◆ CONTROL (P. 81)

ノブモード KNOB MODE

00457-40212
V1.51-210226

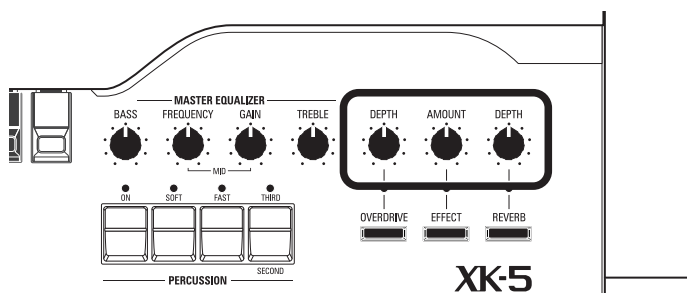
A new parameter, "Knob Mode" has added which allows you to adjust how a value is affected when a knob is moved.

MOMENTARY When a knob is moved, the value will change immediately.

ACROSS..... When a knob is moved the value will not change until the current value is arrived at by the movement of the knob, at which point the value will change.

NOTE: The Knob Mode affects for following knobs; [OVERDRIVE DEPTH], [EFFECT AMOUNT], [REVERB DEPTH].
